**Proposed Development
St. Michael's Convent, London Road, Waterlooville
Final Engineering Appraisal**

**PROPOSED RESIDENTIAL DEVELOPMENT AT ST MICHAEL'S CONVENT,
LONDON ROAD, WATERLOOVILLE - PROPOSED DRAINAGE STRATEGY**

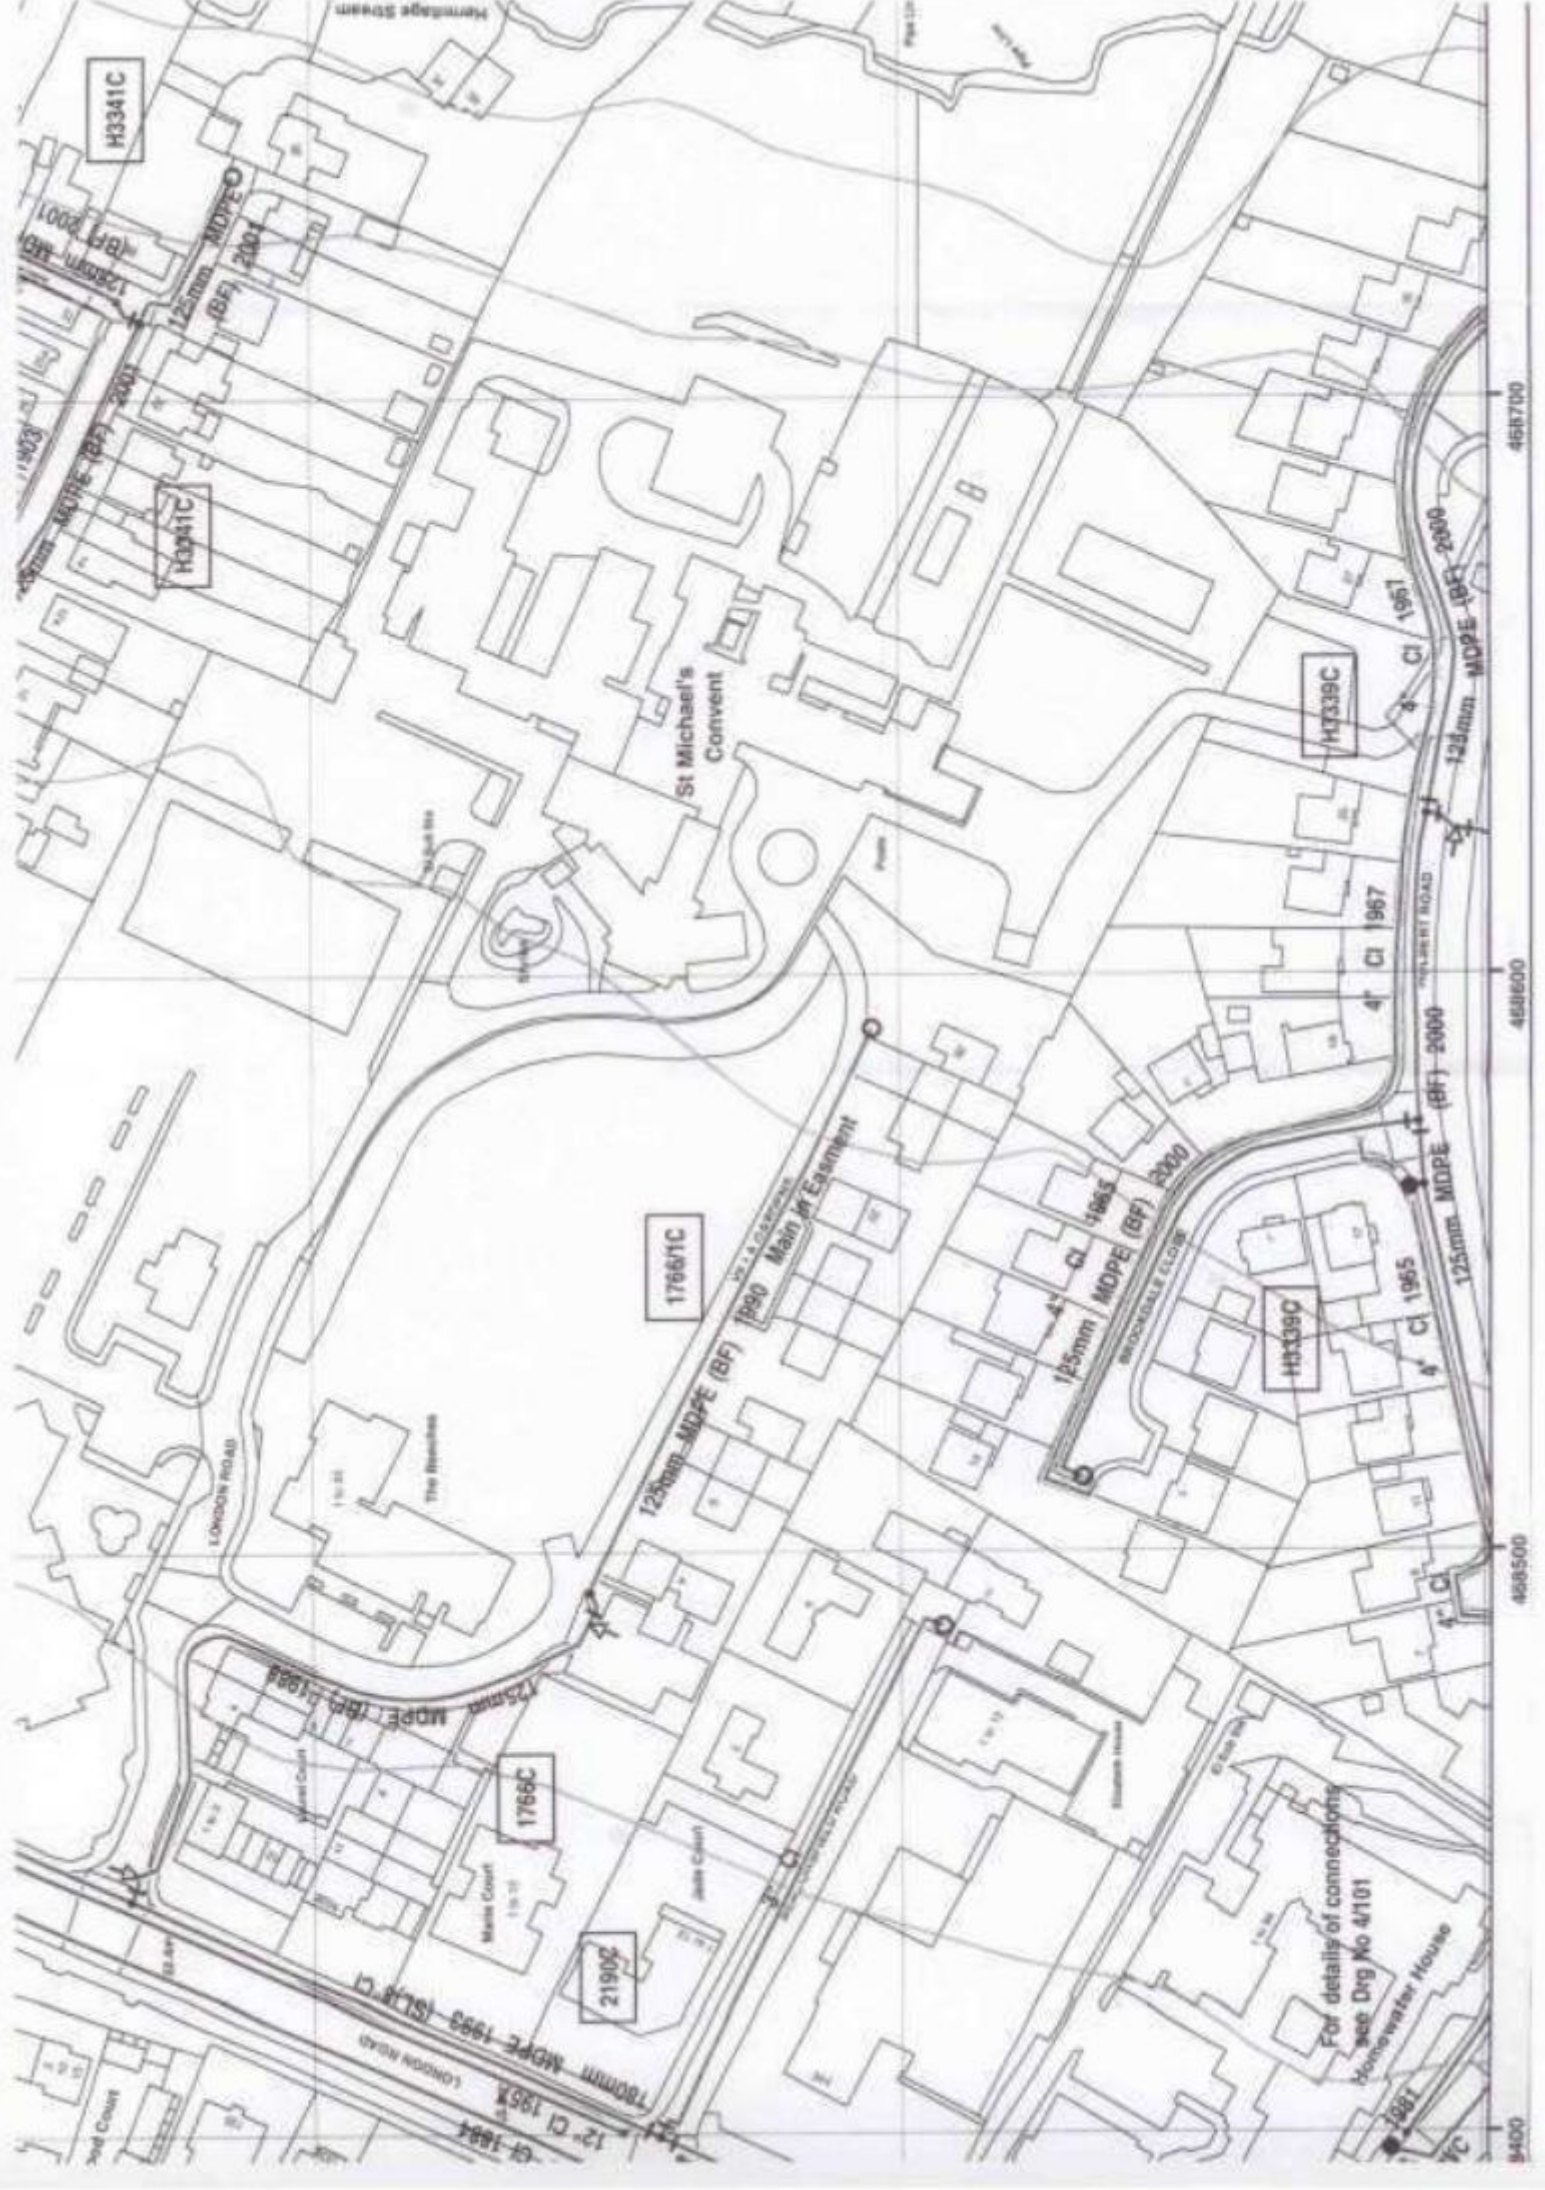
Your proposed site layout does not seem to offer service corridors for any proposed utilities. I note that this drawing is indicative only, however, I would advise you to consider how the units will be supplied by water and other services, especially those which are remote from the access road.

The enclosed extract of Ordnance Survey sheet shows our existing water mains in black line. I regret that I am unable to indicate any other water services that have been taken from these mains but wherever there are surface stopcock or meter boxes, it should be assumed that a service has been connected to the main.

Sewer Plot

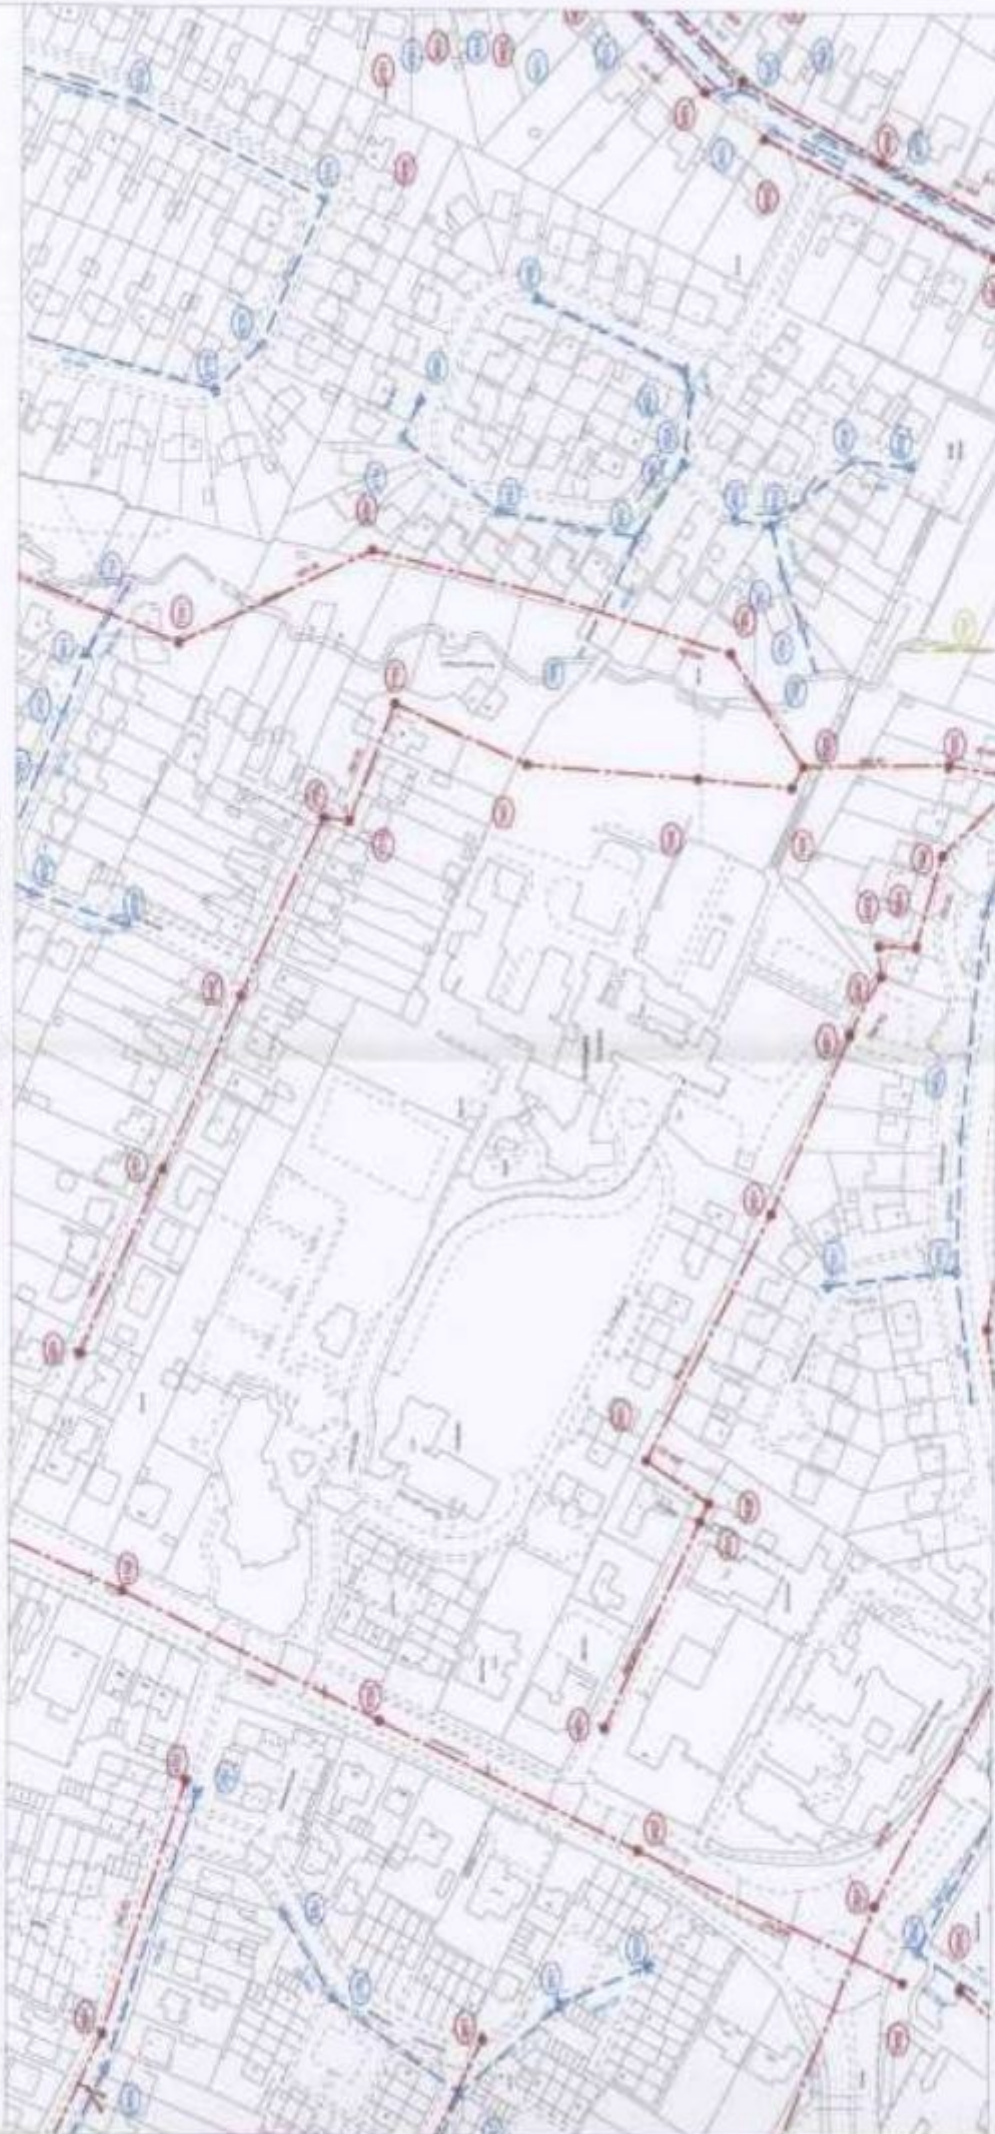
Following initial investigations, there is currently adequate capacity in the local sewerage network to accommodate a foul flow of 3.7 l/s at manhole reference 7503. Please note that no surface water flows (existing or proposed) can be accommodated within the existing sewerage system.
